BCA Assessment Report

ESR Westlink Lot 4
Aldington & Abbots Road Kemps Creek

Revision 0
14th December 2023
Reference: 230446

Figure 2: Rise in Storeys Assessment

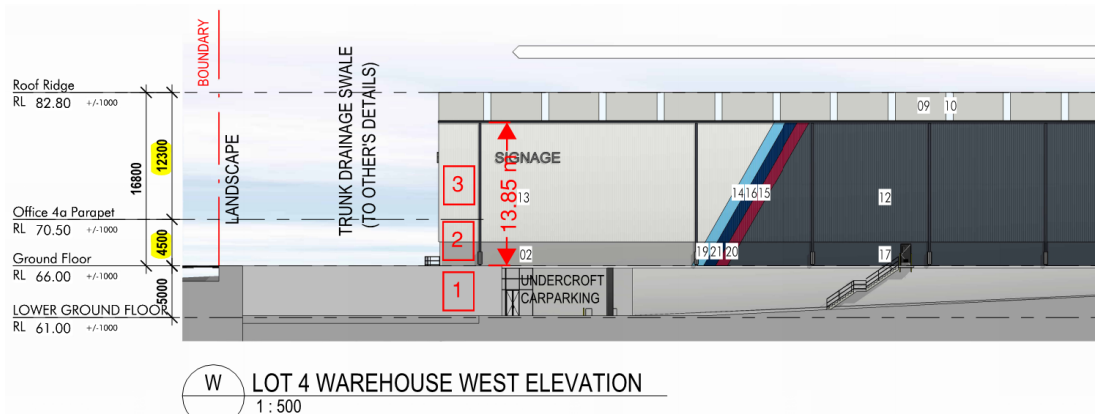
Comment: The proposed development has a rise in storeys of three (3) due to the average internal height of the warehouse building and the overhang of the warehouse above the undercroft carpark. As the warehouse has an average internal height of more than 6m and is not the only storey above ground (the underground carpark being considered 'ground level') the warehouse counts as 2 storeys as per C2D3(3)(b) – see Figure 2 below:

Figure 3: Perimeter Vehicular Access Markup

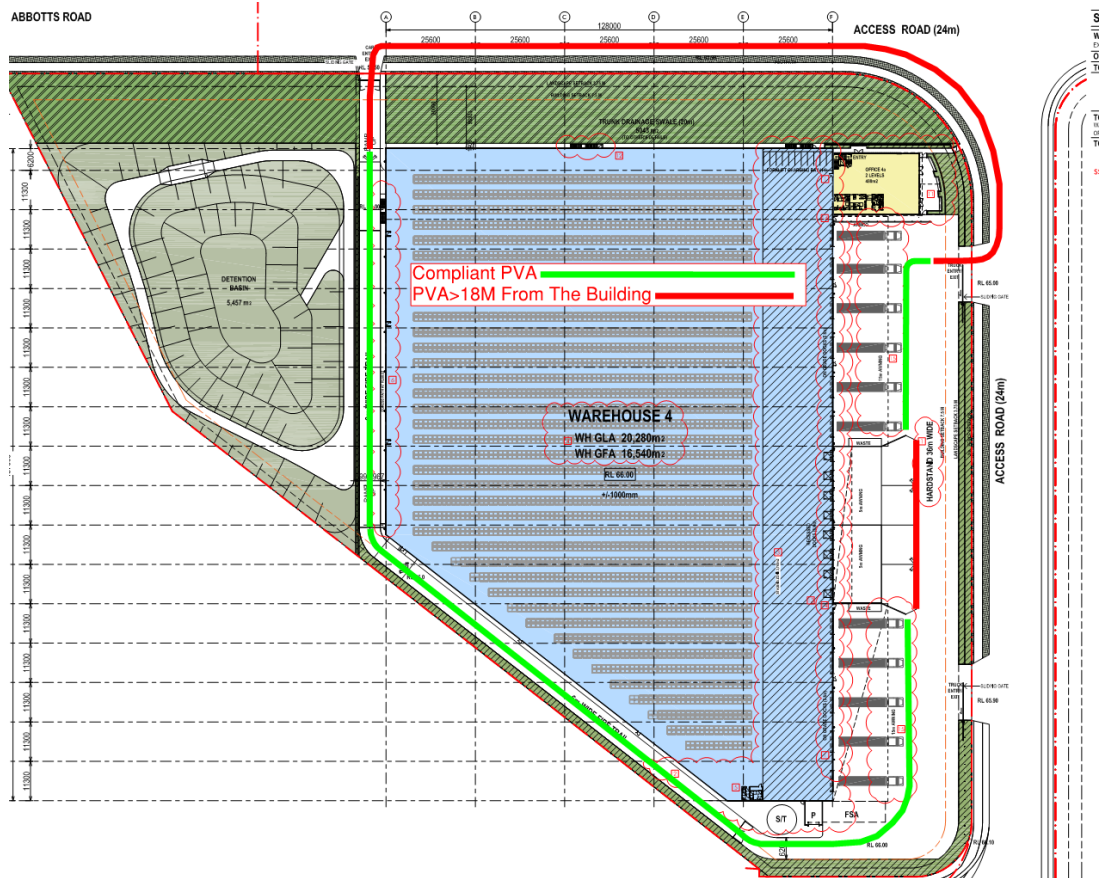
C3D5	<p>Requirements for Open Spaces and Vehicular Access: Open space and vehicular access required by C3D4 must comply with the requirements of sub-clauses (a) & (b) of this Part whereby they must be 6m wide within 18m of the external walls of the building and of a suitable bearing capacity and unobstructed height to permit the operation and passage of FRNSW vehicles.</p> <p>Comment: The proposed warehouse building complies with the provisions of C3D5 except for the areas shown in red and orange on the mark-up overleaf. These non-compliances will be required to be addressed as a performance solution by the Fire Safety Engineer to demonstrate compliance with C1P9:</p> <ul style="list-style-type: none"> + Perimeter Vehicular access is greater than 18m along the northern side of the building as well as around the main office and the recessed loading docs on the Eastern hardstand.

- + Perimeter Vehicular Access is less than 6m wide around the proposed exit stairs on the Western side of the building.

Note 1: Any proposed gates are to achieve no less than 6m unobstructed width or the reduced width will need to be included in the above Performance Solution.

Note 3: The Trial Design for the Fire Engineered Performance Solution must take into consideration and detail the proposed security access to the site and how this may impact on FRNSW vehicular access.

Figure 4: External Wall FRL requirement

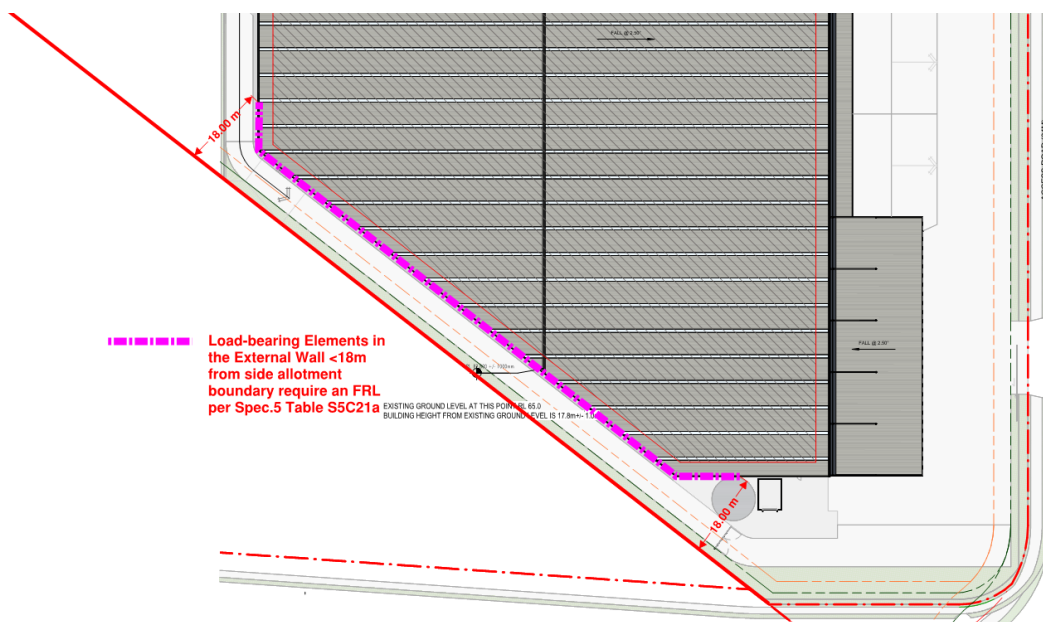
- + All internal load-bearing columns, & walls (excluding those providing direct support to the roof only) are to achieve the required FRL per Table S5C21g: 240/- FRL.
- + The load-bearing elements in the western external wall of the warehouse are required to achieve an FRL per Table S5C21a where the wall is located within 18m of the side allotment boundary – see Figure 4 below:

Note: Any proposal to reduce the FRLs of building elements that are required to be fire rated must be addressed as a Performance Solution from the Fire Engineer.
